**Public Service of New Hampshire d/b/a Eversource Energy**  
**Docket No. DE 20-161**

**Request No. STAFF 1-001**

**Request from: New Hampshire Public Utilities Commission Staff**

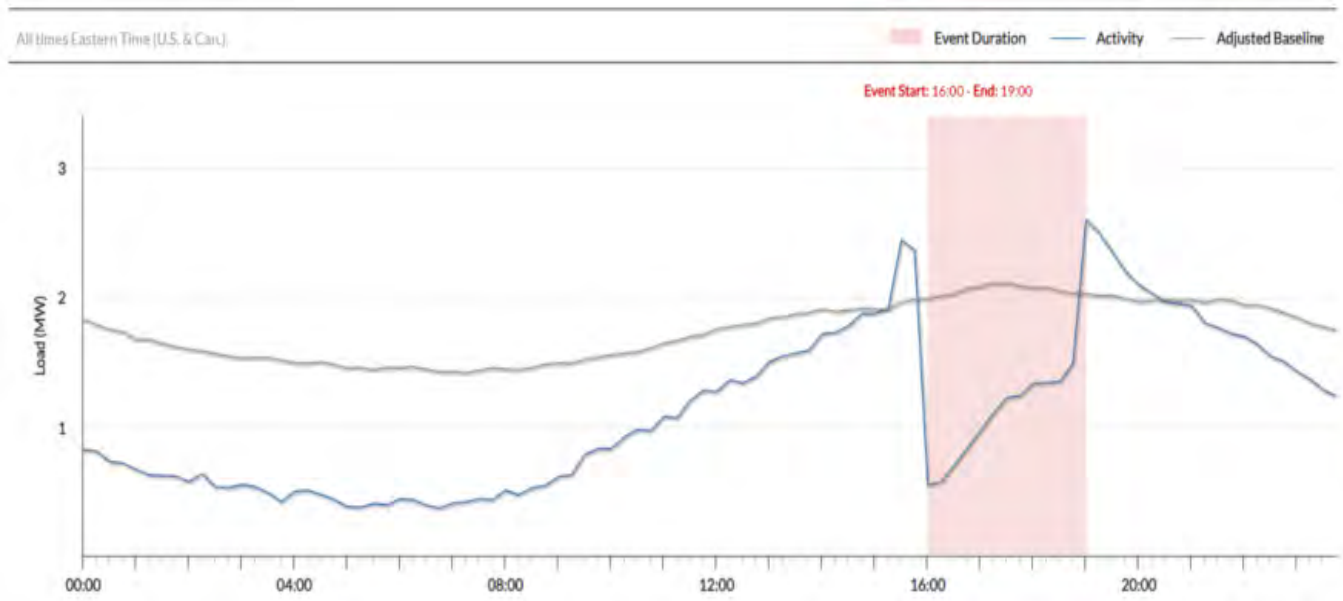
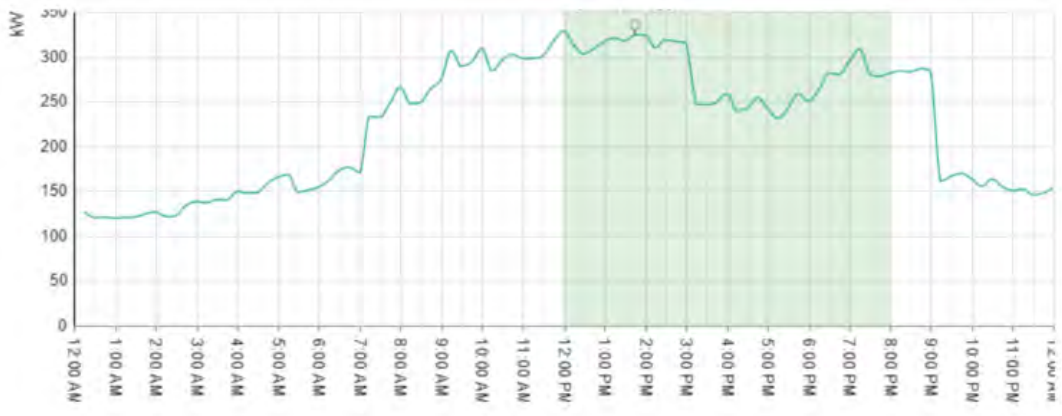
Refer to March 31, 2021 Supplement, Appendix A-1, Bates p. 22 regarding demand response pre-event and snap back periods. Please provide the supporting documentation that shows that shows the pre-event periods and snap back periods and associated load for each for:

- a. NH residential demand response programs
- b. NH commercial demand response programs

A: The below graphs shows the July 27th, 2020 event that was dispatched to approximately 900 NH Residential customers via the Eversource energy efficiency demand response pilot. The event was called from 16:00 - 19:00. The Pre-Cooling and Snapback loads are clearly seen in the hours immediately prior to and after the event duration.

B: The graph below shows a typical commercial participant in Eversource's demand response pilot. The Pre-Cooling load is measurable however not pronounced. The Snapback loads are clearly seen in the hours immediately after the event duration.

STRUCTURE LIMIT C1, C2 AND A3

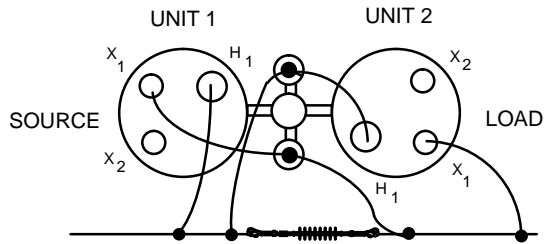
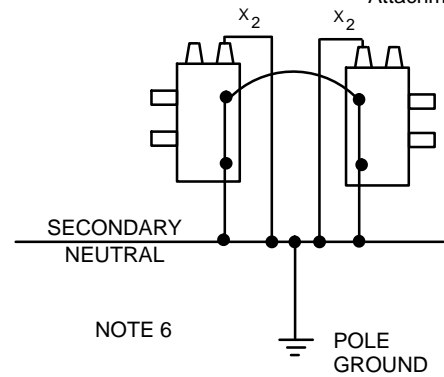
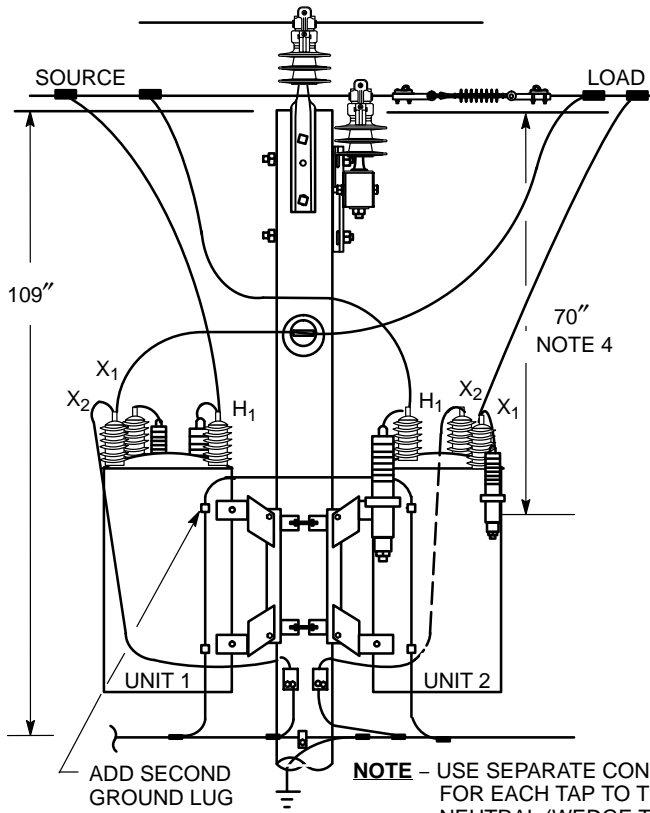
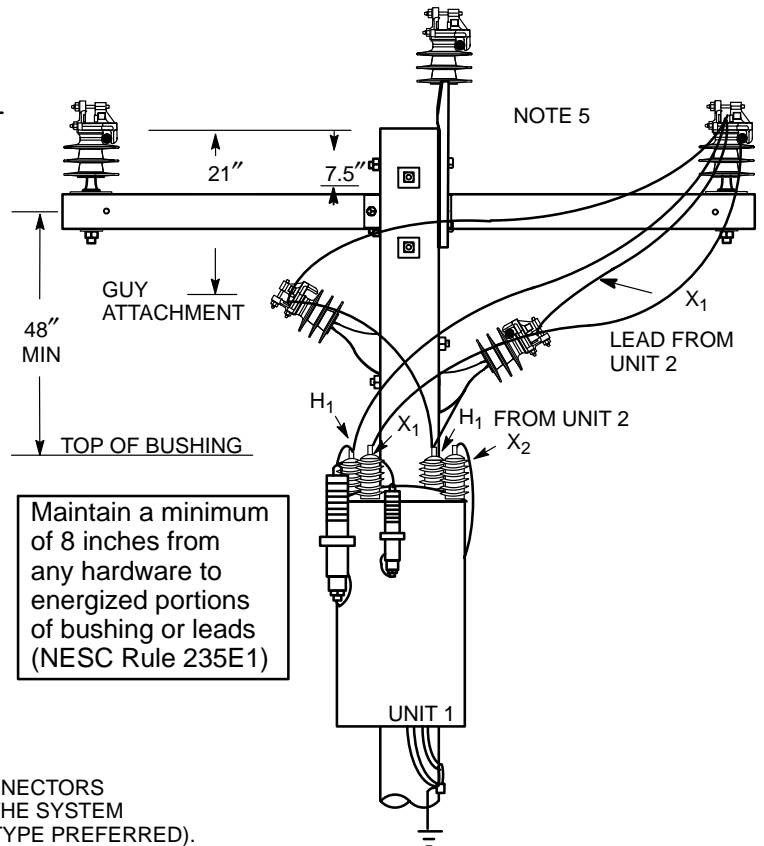
- a. Does the Company have a standard or procedure for installing parallel stepdown transformers? If so, please provide the standard/procedure.
- b. If the stepdown transformers have matched impedances, why does the Company limit the capacity to 100 percent?

- c. Please explain why the number of customers served factors into the capacity of the stepdown transformer?
- d. Please provide the number of stepdown transformer that have failed in the 2016-2020 timeframe that have been loaded between 100-120 percent.

- e. Do all of the parallel stepdown areas have real time load monitoring in order to determine the actual loading of the transformer bank? If not, approximately what percentage of the parallel stepdown locations have real time load monitoring on the units?

- f. For those units that do not have real time monitoring, how does the Company accurately determine the loading on the transformer bank?

- a. The Company construction standard for installing parallel stepdown transformers is attached as Attachment STAFF 1-033a (DTR17.493). Section 14.10 (Transformers General) of the Distribution System Engineering Manual includes this excerpt regarding impedances when paralleling transformers: IMPEDANCE – Single-phase transformers connected in parallel or connected for a three-phase delta-delta bank shall have the same voltage rating, be set on the same primary tap (if applicable), and have impedances that are approximately equal. An impedance variation limit of plus or minus 7 percent, one transformer to another, is acceptable. For example if transformers are intended to be connected in parallel and one unit has an impedance of 2.5%, the other unit has to be within the range of 2.3 – 2.7%. For a bank of three transformers, if the unit with the lowest impedance is 2.5%, the unit with the highest impedance can not be more than 2.7%. The impedance of the third unit must be within the range of the other two units. Failure to meet all these conditions can result in unequal load division and undesirable circulating currents.

- c. The number of customers served does not determine the capacity of the stepdown transformer. The consideration of the exposure to the number of customers served by 1 MW of capacity per phase to a lengthy outage and potentially 3MW of load served during repairs is one basis for limiting the load served to 1MW. An additional benefit to limiting the loading on parallel steps is the increased ability to continue to serve customers on the remaining step during non-peak load times while efforts to replace the failed step are underway.

- e. During the summer of 2020, 102 out of 110 instances with parallel 500 kVA steps were equipped with either SCADA or Aclara line sensors which provide real time load monitoring. A three-phase installation (three sets of parallel 500 kVA steps) is counted as three instances for the purposes of this response.

- f. The remaining locations typically have a Spear recloser as protection on the secondary side which can be downloaded to obtain the loading information or the Company can use upstream loading obtained from a SCADA device and extrapolate the data. The Company also has various line sensors that can be installed temporarily if needed to capture loading data. The Company continues to add real time monitoring to those parallel stepdown locations which presently do not have this capability.
